ENVIRONMENTAL EVALUATION GROUP

Enclosed is a copy of a paper, titled *Evaluation of Proposed Panel Closure Modifications at the WIPP* by Allen, Abel and Morgan. The paper summarizes work performed and discussed in EEG-82, by Lawrence Allen et al, November 2001. The paper has been accepted for presentation in February 2003 at the annual meeting of the Society for Mining, Metallurgy, and Exploration (SME). This work does not address the most recent panel closure submittals to EPA and NMED (October 2002) because of paper submittal deadlines, although an update of proposed panel closure plans can be included in the presentation.

Evaluation of Proposed Panel Closure Modifications at the
Waste Isolation Pilot Plant

Figure 3
Options C and D for Panel Closure Design

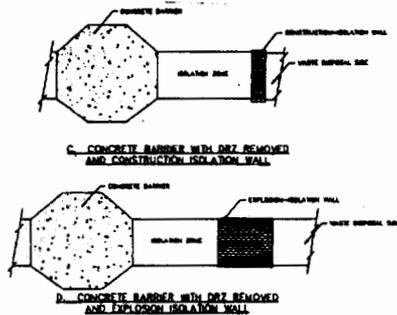
2. Replace the explosion wall with a construction wall.

This modification is acceptable. A methane explosion cannot occur sooner than 15 to 20 years following panel closure and the concrete barrier bulkhead will be constructed within a year after that time. Analysis has demonstrated that a 1.2 m construction wall is adequate to protect against roof fall overpressure until the concrete bulkhead is completed (Abel 2001). The construction-isolation wall is shown in Option C in Figure 3.

Figure 4
Concrete Bulkhead Design.
(DOE 1996b)

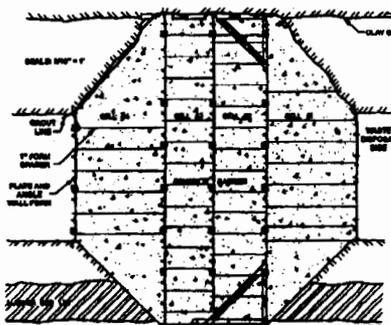
6. Option to allow steel forms to be left in place or removed.

By providing the concrete contractor the option of either leaving the forms in place or removing them, DOE's intent is to try to reduce the number of forms remaining in the concrete bulkhead and thus reducing potential contamination migration pathways. It is EEG's opinion that rather than give the contractor the option, removing the forms should be mandated and the number of cells comprising the bulkhead should be reduced. This would also reduce potential migration pathways.

The size of these bulkheads probably precludes a monolithic single cell, but the number of cells could certainly be reduced from four or three to two. EEG recommends:

- The contractor be provided an incentive to minimize the number of cells.
- It be required that each cell be filled as a continuous monolithic concrete pour.
- It be required that the contractor support the fluid concrete in all cells with external structures.
- It be required that the contractor remove the support structures and forms between internal cells.
- That the contractor provide for a rough form surface between internal cell walls (possible with a layer of burlap).
- That the contractor should assure some grout points are located at the roof concrete/rock salt contact.
- That the use of all internal form spacer supports is prohibited.
